**ARINC SPECIFICATION 858 PART 3
TABLE OF CONTENTS**

The Common IPS Radio Interface (CIRI) protocol specified in this standard is intended to facilitate this harmonization by providing a standardized means to exchange status and information in a manner that allows different radios to assess/present link status and to handle the flow of information consistent with the radio's abilities. Therefore, the CIRI protocol should be adopted, by reference to this standard, as the radio standards are updated.

Figure 2-1 – Common IPS Radio Interface

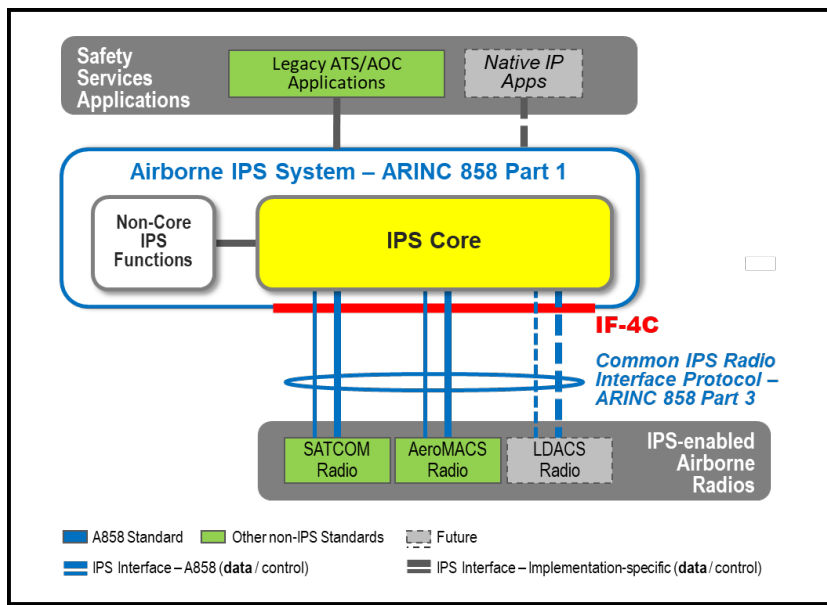
Commented [SM2]: M23 – Definition of IF-4 in Part 1 needs to be fixed – it is not expected that Airborne IPS System would control the radios (tune frequencies, etc.)

Commented [OML3R2]: Figure updated consistent with changes to figure in A858P1.

Figure 2-2 – Notional CIRI Protocol Context

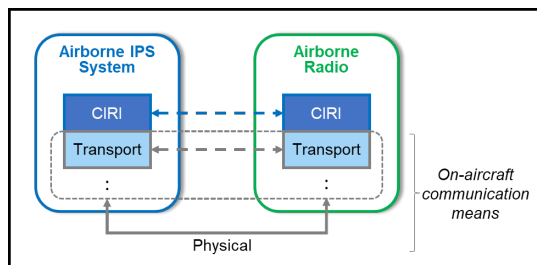
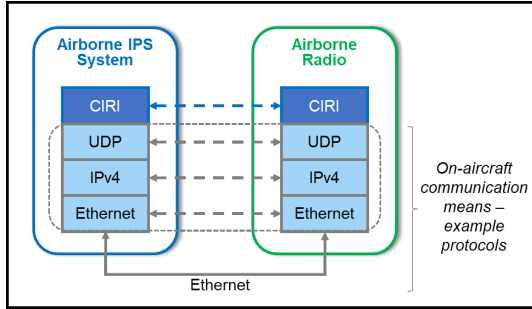
Commented [SM11]: [P3-M22-01 – M.Skorepa/Z.Jaron-HON]: Clarify the diagram to indicate that it is an example, or abstract the diagram.

Commented [OML12R11]: M23 – Fig 2-2 is abstracted; Fig 2-3 is example.

Figure 4-1 – Airborne IPS System Endpoint Control Plane Operation

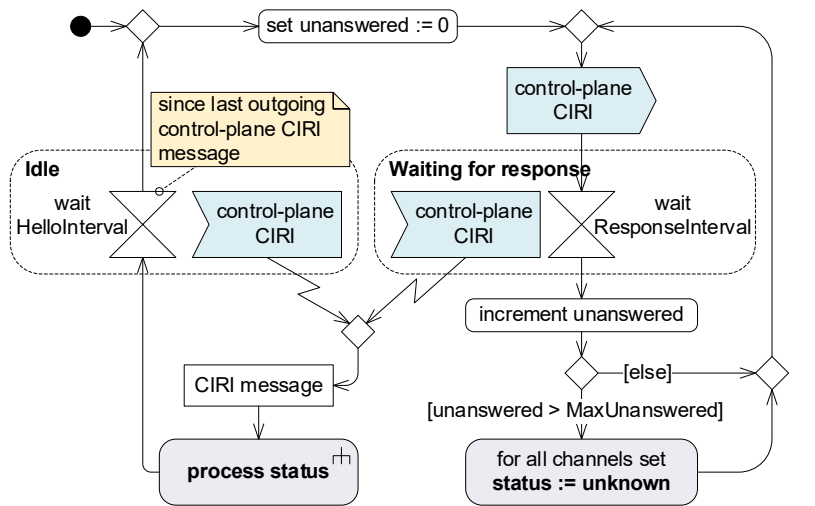
Also, the flow control paragraphs may be moved below the Figure 4-1.
